City of Detroit CITY PLANNING COMMISSION

RE: Request of Mariners' Church of Detroit for PC (Public Center) Special District Review of proposed exterior alterations to 170 East Jefferson Avenue – Mariners' Church of Detroit

(RECOMMEND APPROVAL WITH CONDITIONS)

Following is the review by the Planning and Development Department (PDD) of the Mariner's Church Master Plan for 170 E Jefferson Ave. (BSEED Permit number BLD2022-02014). The church was listed on the National Register of Historic of Historic Places in 1971. As the property is zoned PC (Public Center), this review is required under Sec. 50-11-96 of the City of Detroit Zoning Ordinance.

principal in charge project manager project architect 07.28.2022

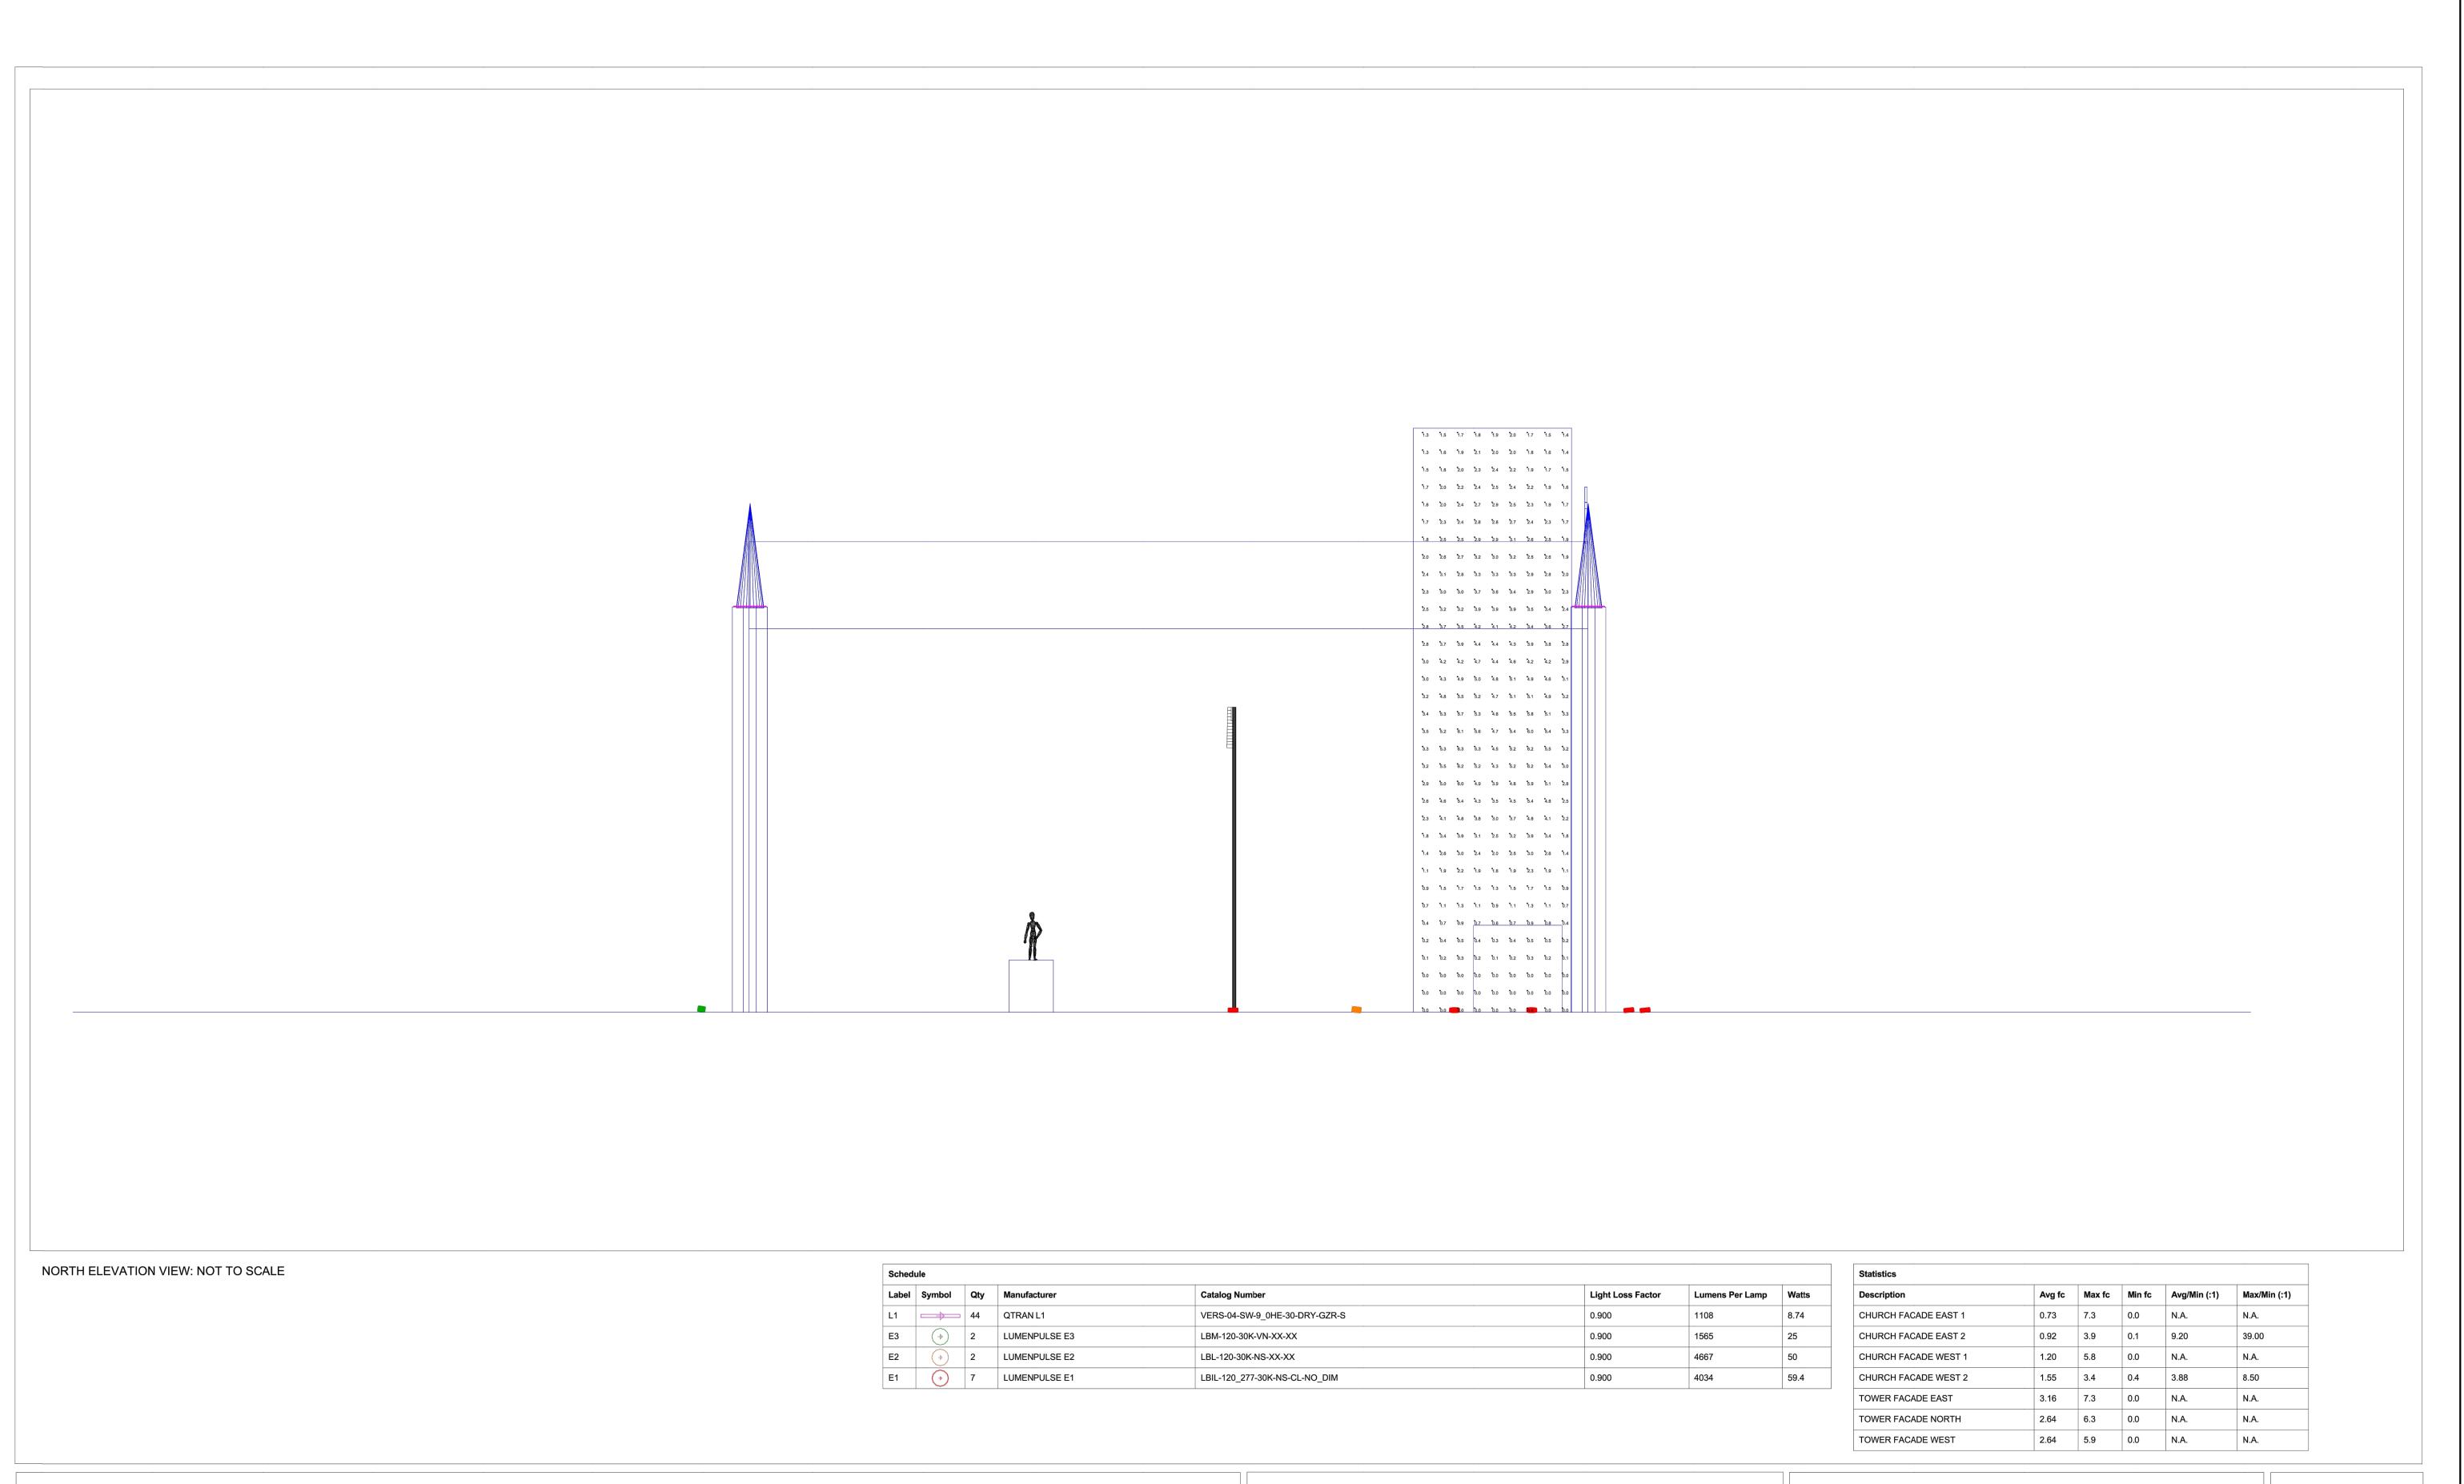
- b. CPC staff finds that the revised Site Lighting plan dated July 28, 2022, would take reasonable measures to limit light spillover and nightglow as illuminance levels depicted on sheets A106, A108, and A110 indicate that the highest levels of illuminance would be focused on building facades, the tower, and pinnacles, and would not be focused off-site or directly into the sky. Additionally, there are numerous examples of buildings, especially churches, located within the Central Business District that have similar focused up-lighting provided.
